# Access Compliance Report

## Public Rights-of-Way

### (Curb Ramps)

Intersection ID: 44487	Main Street: REAMES_RD	Cross Street: FINN_HALL_AV	Location: W
ADA ID: E9B8CB006F23	Ramp Type: Perp	Initial Pass/Fail: Fail	Overall Compliance: No
		Severity Score: 10

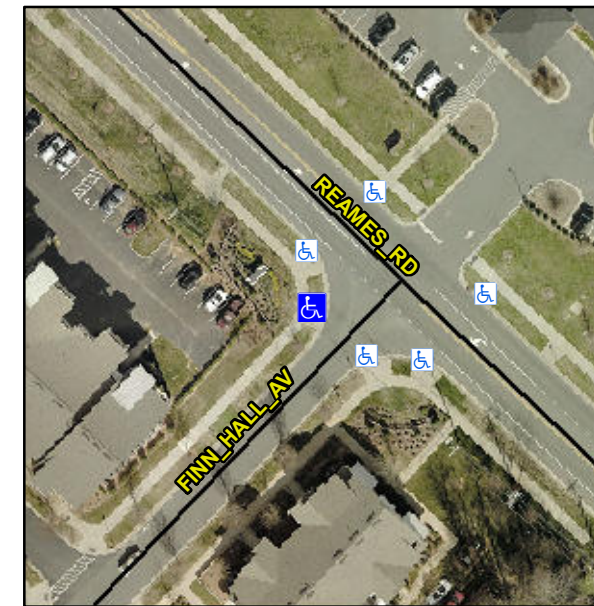
**Not Found, R304.5.1, R304.5.3**

Compliance	Description	Data	Compliance	Description	Data
N/A	Ramp Length (in)	96.0	Yes	Ramp Slope (%)	7.6
No	Ramp Width (in)	47.5	No	Ramp XSlope (%)	2.6
N/A	Flare Type LT	N/A	N/A	Flare Type RT	N/A
N/A	Flare Slope LT (%)	N/A	N/A	Flare Slope RT (%)	N/A
N/A	Flare Traversable LT?	N/A	N/A	Flare Traversable RT?	N/A
N/A	Landing Length (in)	N/A	N/A	DWS Provided?	N/A
N/A	Landing Width (in)	N/A	N/A	DWS Contrast?	N/A
N/A	Landing Slope (%)	N/A	N/A	DWS Length (in)	N/A
N/A	Landing X Slope (%)	N/A	N/A	DWS Full Width?	N/A
N/A	Landing Curb? (Y/N)	N/A	N/A	DWS Offset (in)	N/A
N/A	Shared Landing?	N/A			
N/A	Gutter Ponding?	N/A	N/A	Gutter Slope (%)	N/A
N/A	Gutter Lip Ht (in)	N/A	N/A	Gutter X Slope (%)	N/A
N/A	Painted X Walk1?	No	N/A	Painted X Walk2?	N/A
	X Walk 1 Direction	To S		X Walk 2 Direction	N/A
N/A	X Walk 1 Width (in)	N/A	N/A	X Walk 2 Width (in)	N/A
	X Walk 1 Slope (%)	0.9		X Walk 2 Slope (%)	N/A
	X Walk 1 X Slope (%)	2.2		X Walk 2 X Slope (%)	N/A

**Remove & Replace Entire Ramp.**
